SP Garments Ltd (Extension 2)

7 October 2024

1. Building Information

Dining Building

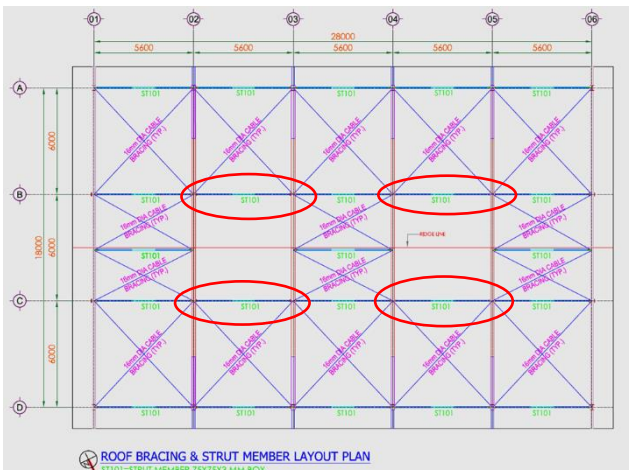
Observation-1: Design report required to be reviewed by RSC for lateral loading. (Dining Building)

Strut member layout

Strut member missing on-site

Description: A set of design reports for the dining building was available. The design report needs to be reviewed for lateral loading.

Moreover, the marked strut members were not found on-site. The building engineer is required to survey the full structure and prepare complete as-built structural drawings. Also, the stability system should be checked, considering the strut member's position at the site.
